I PROJECT:	Wynot Public School Addition & Renovation	PROJECT NO.	L14208
FROM:	BVH Architects	DATE:	17 March 2016
TO:	All Bidders	ADDENDUM NO.	1

Wynot Public School Addition and Renovation
R.O. Youker, Inc. Project #16005
Addendum 1 Items
3/17/2016

addendum no. 1

ES2

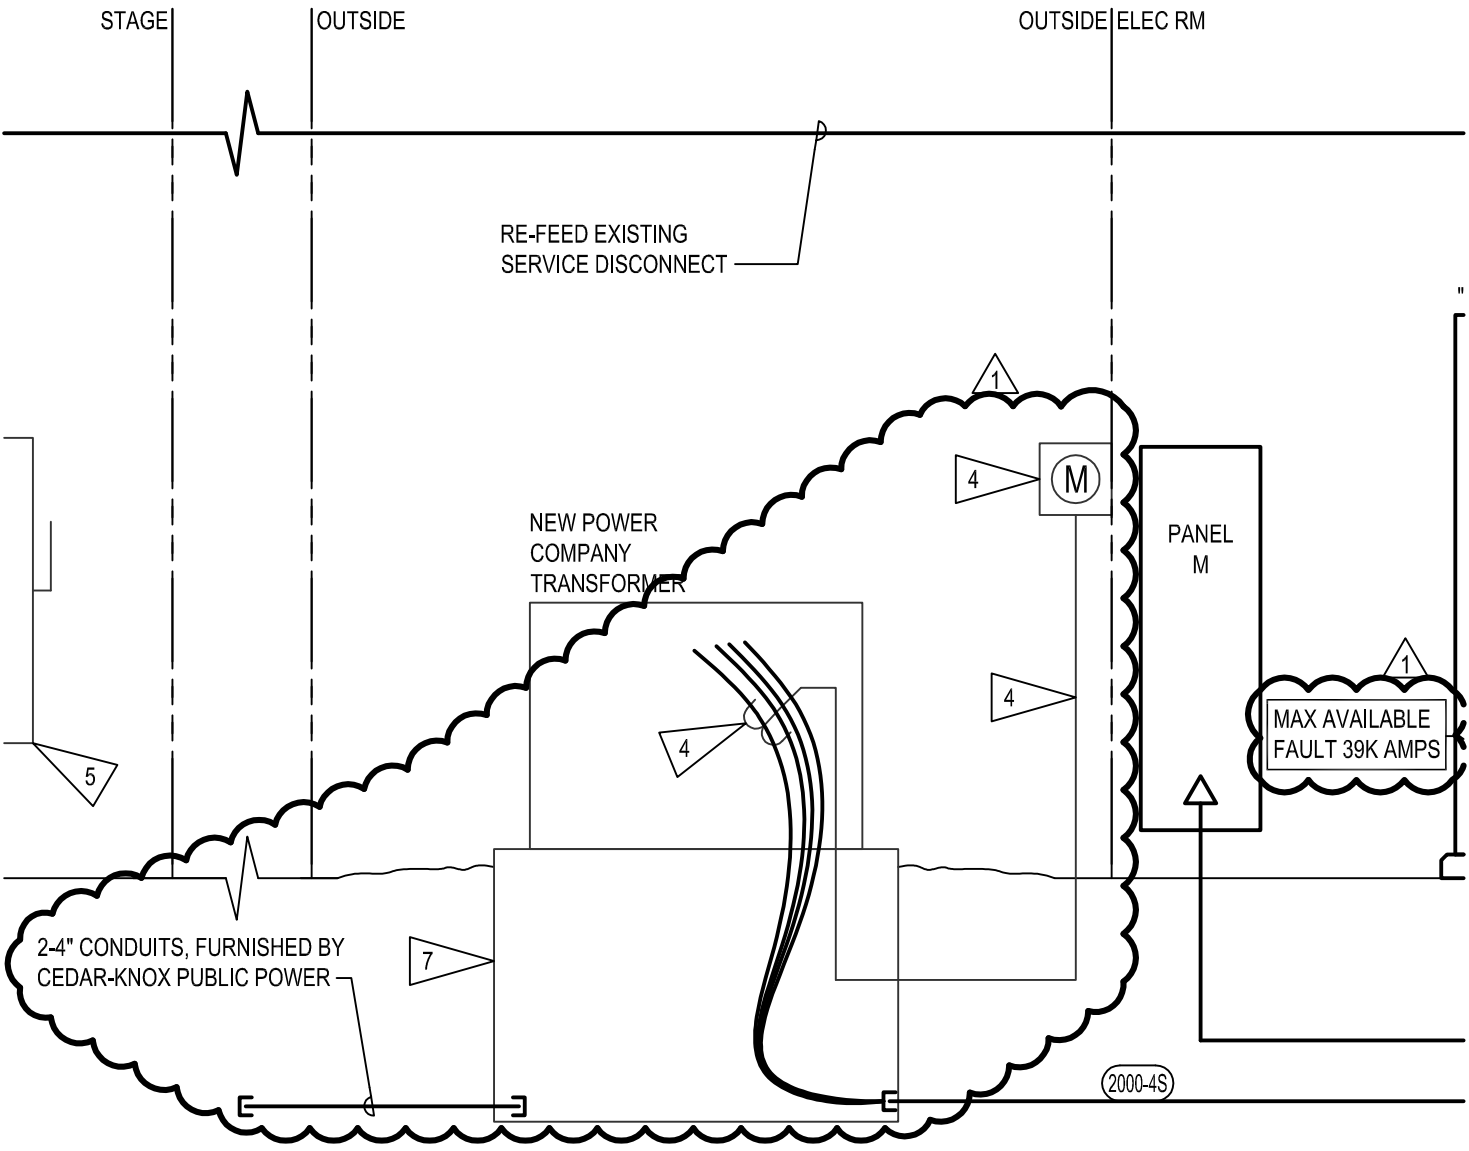
5. Sheet E4.1 – Electrical Schedules & Riser Diagram
 - ii. Riser Diagram – Delete “12”=1’-0”” and replace with “NOT TO SCALE”.
 - iii. Riser Diagram – See attached supplemental drawing ES2 for additional work.

- 1 4 METERING, CONDUIT, CONDUCTORS AND CT'S PROVIDED BY CEDAR-KNOX PUBLIC POWER.
- 5 FIELD VERIFY EXISTING BUILDING GROUNDING ELECTRODES AND NUETRAL TO GROUND BOND LOCATION. REMOVE NEUTRAL TO GROUND BOND AT EXISTING SERVICE.
- 6 COORDINATE ROUTING OF FEEDER WITH FUTURE PHASING PLANS. DO NOT ROUTE FEEDER THROUGH AREAS OF BUILDING SCHEDULED FOR DEMOLITION.
- 1 7 INSTALL FIBERGLASS VAULT FURNISHED BY CEDAR-KNOX PUBLIC POWER. TERMINATE PRIMARY AND SECONDARY CONDUITS IN VAULT. COORDINATE CONDUIT TERMINATIONS, BACK-FILL, AND INSTALLATION REQUIREMENTS WITH CEDAR-KNOX PUBLIC POWER.
